CITY OF PROVIDENCE, RHODE ISLAND

**RFP Title: Lilian Feinstein Elementary School Art Room & Office Renovations**

**Addendum #: 1**

Addendum Date: October 5, 2026  
Project: Lillian Feinstein Elementary School  
Art Room and Office Renovation

2 PARTIAL BASEMENT REFLECTED CEILING PLAN - DEMOLITION  
AR101 SCALE: 1/2" = 1'-0"

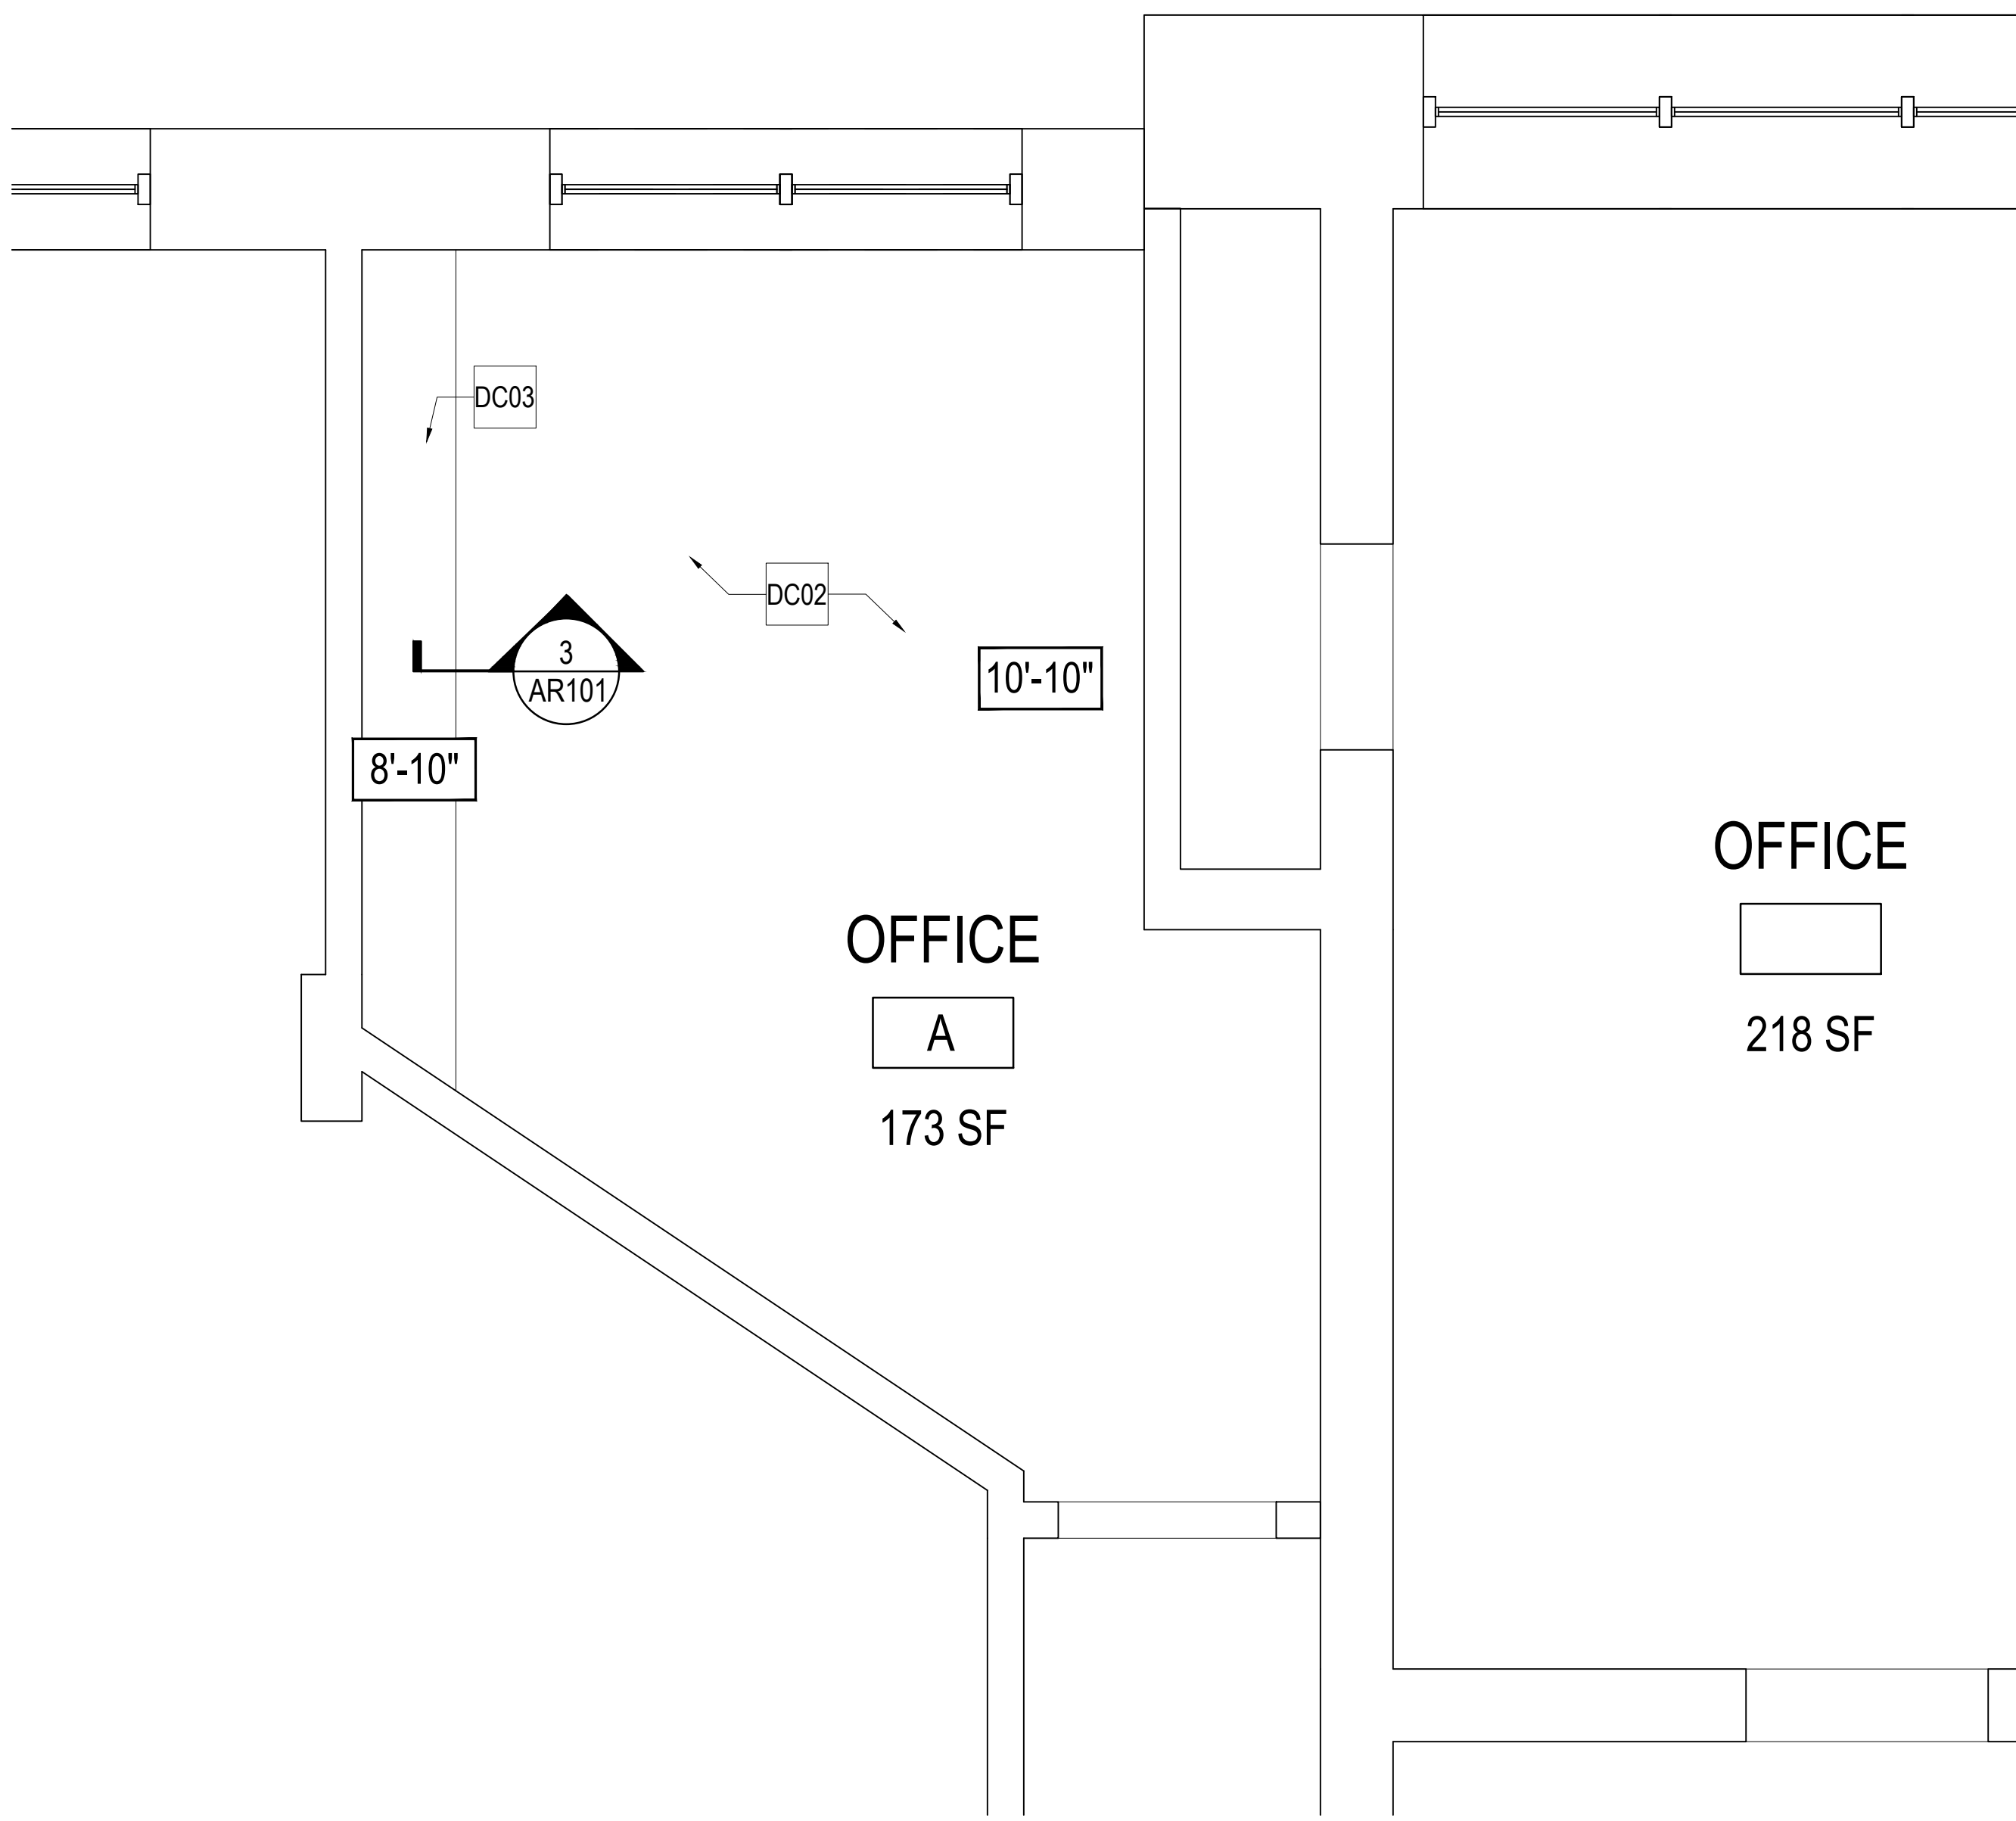
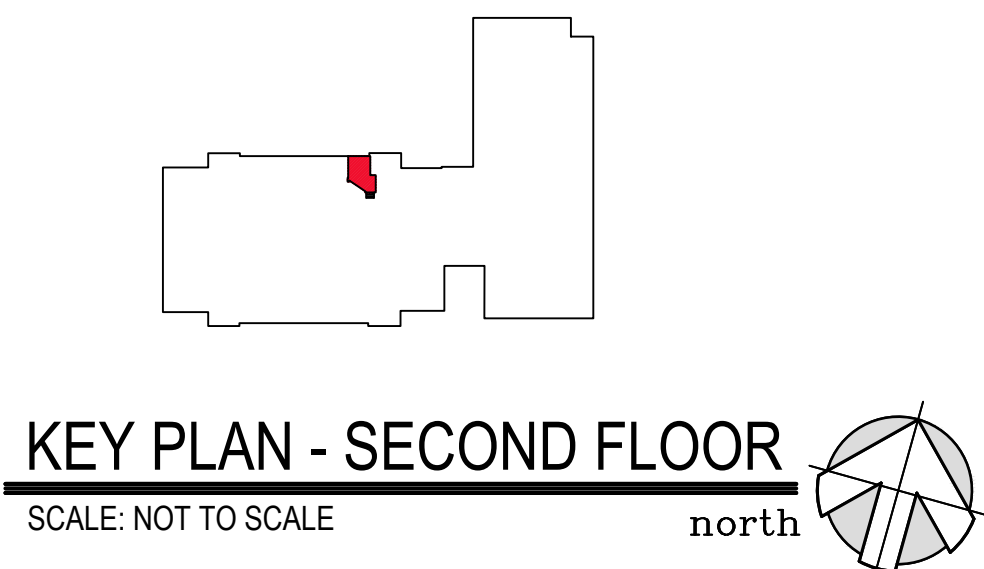
24. The basement reflected ceiling plan 2/AR-101 contains the note, “existing sprinkler pipes Re: FP drawings for basis of new design. The drawings do not include Fire Protection plans.

**Response: Existing automatic fire suppression system (sprinkler heads) shall be modified to accommodate new drop ceiling. The design shall be by the fire suppression subcontractor and submitted to the design team for review.**

**Response: Refer to response in item #15 above.**
